Access Compliance Report

Public Rights-of-Way

(Curb Ramps)

Intersection ID: N/A	Main Street: CANTERBURY_CASTLE_DR	Cross Street: SAGMORE_HILL_DR	Location: S
ADA ID: 7FDFEB8F2A60	Ramp Type: BlendTrans1	Initial Pass/Fail: Fail	Overall Compliance: No
Severity Score: 8.75			
Codes/Mitigation Info/Possible Solution		Field Measurements/Component Compliance

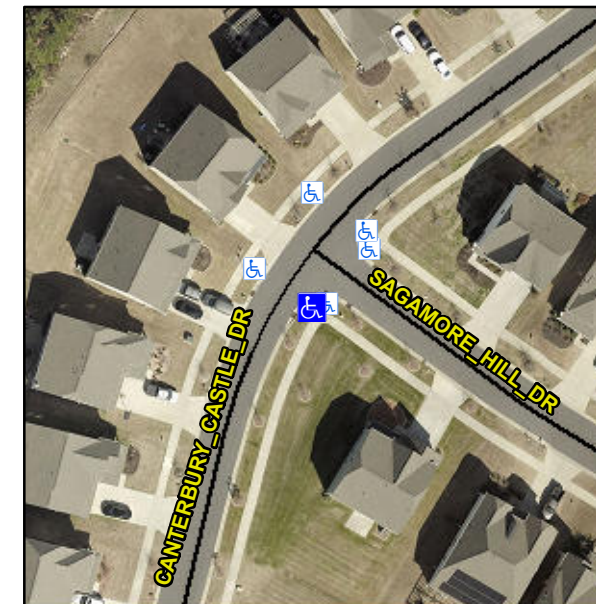
R304.5.1

Compliance	Description	Data	Compliance	Description	Data
N/A	Ramp Length (in)	96.0	Yes	BlendTrans Slope (%)	4.2
No	Ramp Width (in)	45.5	Yes	BlendTrans XSlope (%)	0.5
N/A	Flare Type LT	N/A	N/A	Flare Type RT	N/A
N/A	Flare Slope LT (%)	N/A	N/A	Flare Slope RT (%)	N/A
N/A	Flare Traversable LT?	N/A	N/A	Flare Traversable RT?	N/A
N/A	Landing Length (in)	N/A	N/A	DWS Provided?	N/A
N/A	Landing Width (in)	N/A	N/A	DWS Contrast?	N/A
N/A	Landing Slope (%)	N/A	N/A	DWS Length (in)	N/A
N/A	Landing X Slope (%)	N/A	N/A	DWS Full Width?	N/A
N/A	Landing Curb? (Y/N)	N/A	N/A	DWS Offset (in)	N/A
N/A	Shared Landing?	N/A			
N/A	Gutter Ponding?	N/A	N/A	Gutter Slope (%)	N/A
N/A	Gutter Lip Ht (in)	N/A	N/A	Gutter X Slope (%)	N/A
N/A	Painted X Walk1?	No	N/A	Painted X Walk2?	N/A
	X Walk 1 Direction	To NW		X Walk 2 Direction	N/A
	X Walk 1 Width (in)	N/A		X Walk 2 Width (in)	N/A
	X Walk 1 Slope (%)	2.8		X Walk 2 Slope (%)	N/A
	X Walk 1 X Slope (%)	1.9		X Walk 2 X Slope (%)	N/A

Remove & Replace Curb Ramp With Two New Directional Ramps or Equivalent.
